**RC10
B6.4
TEAM KIT**

RC10B6.3 vs. RC10B6.4 Comparison

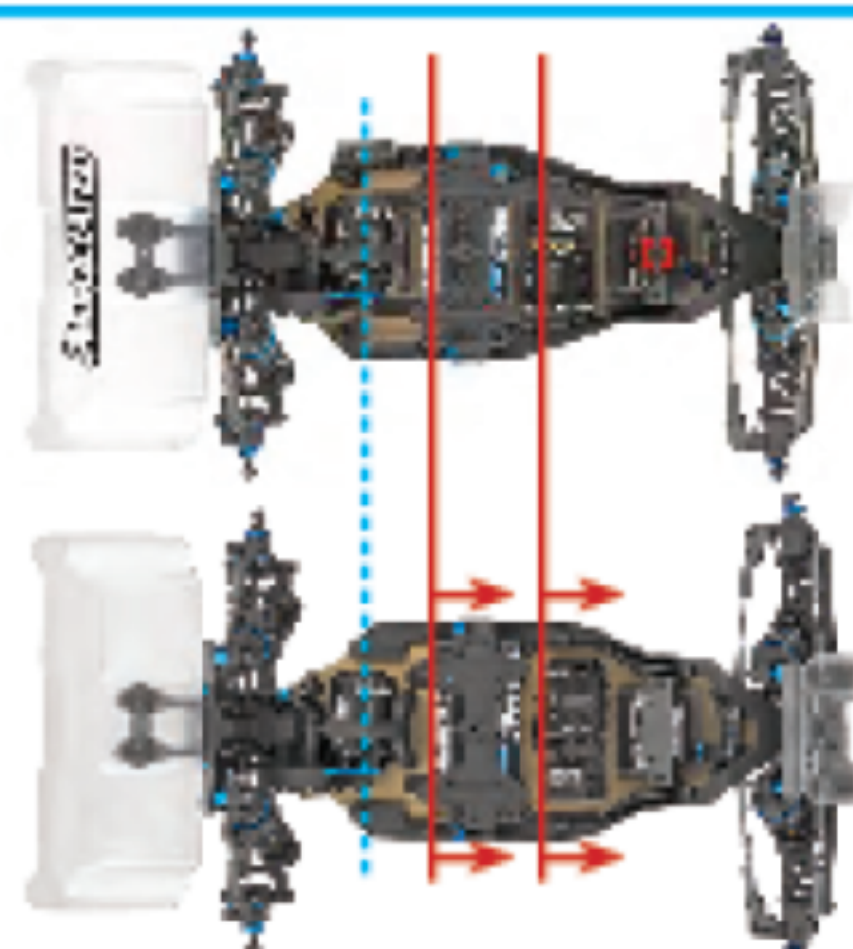
Updated top plate and ballstud mount

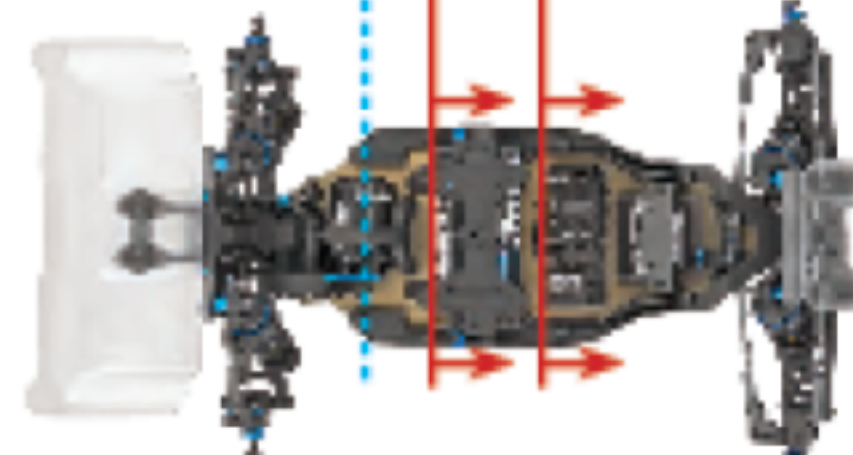
New chassis profile and ESC tray location. B6.4 has weight moved forward.

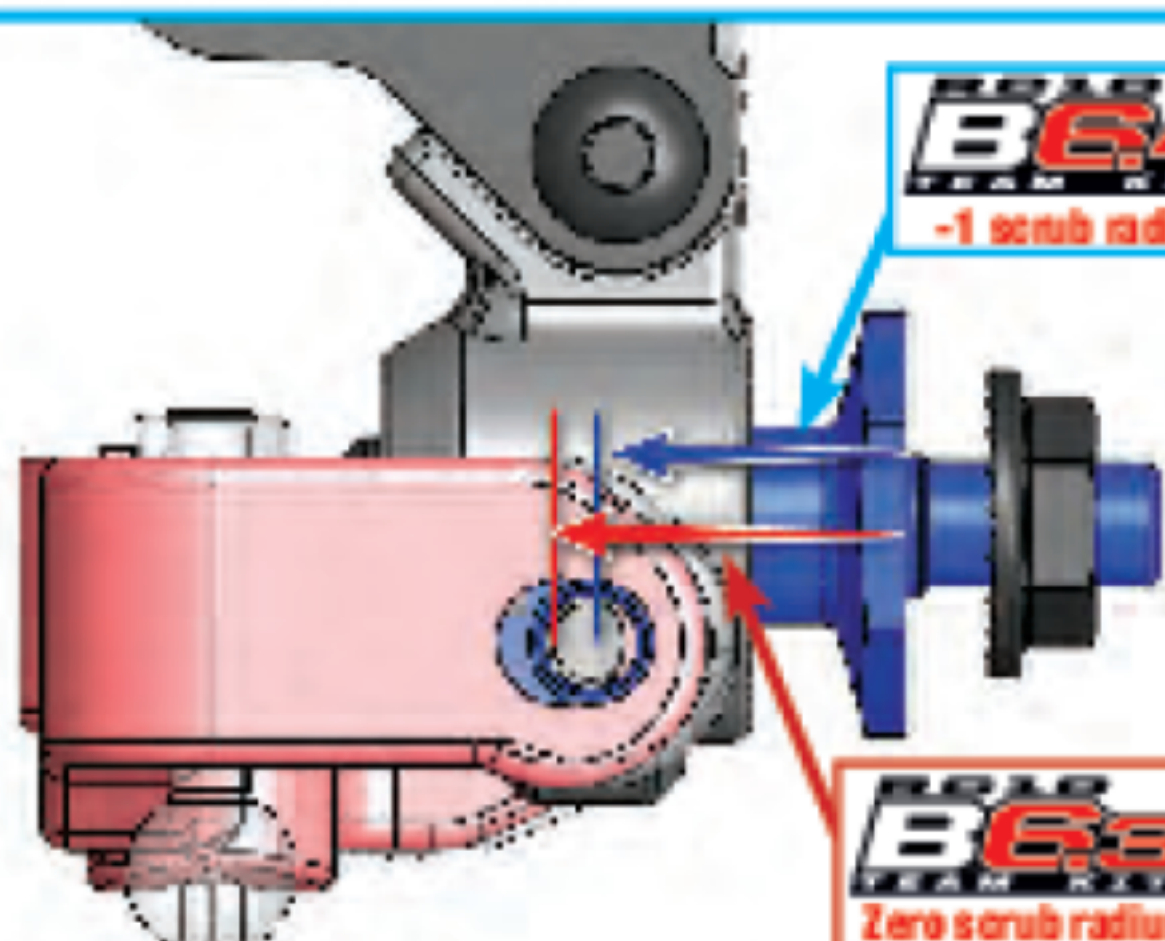
New adjustable height steering system.
B6.3 is not adjustable
